Access Compliance Report

Public Rights-of-Way

Intersection ID: 8367	Main Street: KENTUCKY_AV	Cross Street: NELSON_AV	Location: NE
ADA ID: D2124C7844A1	Ramp Type: BlendTrans1	Initial Pass/Fail: Pass	Overall Compliance: No
		Severity Score: 15

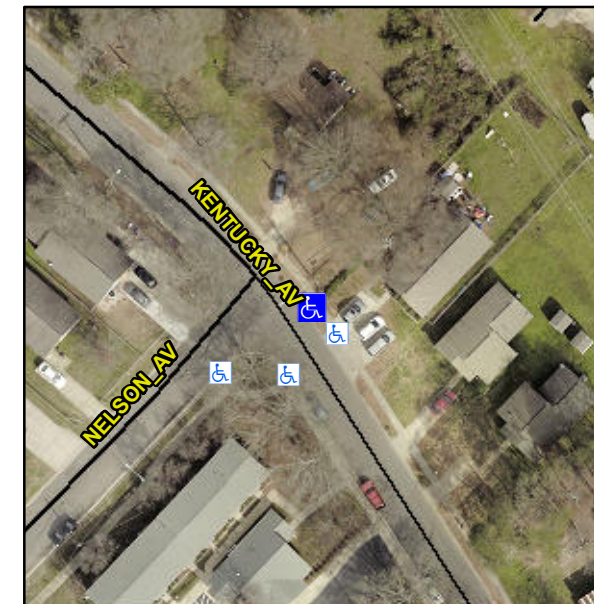
Not Found, R305, R304.5.4

Compliance	Description	Data	Compliance	Description	Data
N/A	Ramp Length (in)	47.5	Yes	BlendTrans Slope (%)	2.4
Yes	Ramp Width (in)	58.0	Yes	BlendTrans XSlope (%)	0.8
N/A	Flare Type LT	None	N/A	Flare Type RT	None
N/A	Flare Slope LT (%)	N/A	N/A	Flare Slope RT (%)	N/A
N/A	Flare Traversable LT?	N/A	N/A	Flare Traversable RT?	N/A
Yes	Landing Length (in)	60.0	No	DWS Provided?	No
Yes	Landing Width (in)	58.0	N/A	DWS Contrast?	No
Yes	Landing Slope (%)	0.7	N/A	DWS Length (in)	N/A
Yes	Landing X Slope (%)	0.7	N/A	DWS Full Width?	No
N/A	Landing Curb? (Y/N)	No	N/A	DWS Offset (in)	N/A
N/A	Shared Landing?	No			
Yes	Gutter Ponding?	No	No	Gutter Slope (%)	11.7
Yes	Gutter Lip Ht (in)	0.0	Yes	Gutter X Slope (%)	1.6
N/A	Painted X Walk1?	No	N/A	Painted X Walk2?	N/A
	X Walk 1 Direction	To SW		X Walk 2 Direction	N/A
	X Walk 1 Width (in)	N/A		X Walk 2 Width (in)	N/A
	X Walk 1 Slope (%)	3.3		X Walk 2 Slope (%)	N/A
	X Walk 1 X Slope (%)	1.1		X Walk 2 X Slope (%)	N/A

N/A	Ramp inside XWalk1?	N/A	N/A	Ramp inside XWalk2?	N/A
	Road Slope (%)	1.1		Clear Space?	Yes
	Road X Slope (%)	3.3	N/A	Clear Space to XWalk (in)	N/A
Yes	Any Obstructions?	No	Yes	Storm Grate/Utility Hazard?	No
	Obstruction Type			Storm Grate/Utility Type	
		N/A			N/A
			Yes	Surface Condition? (G/P)	Good
			No	Curb Slope (%)	32.7

Remove & Replace Curb Ramp With Two New Directional Ramps or Equivalent. Remove & Replace Gutter.
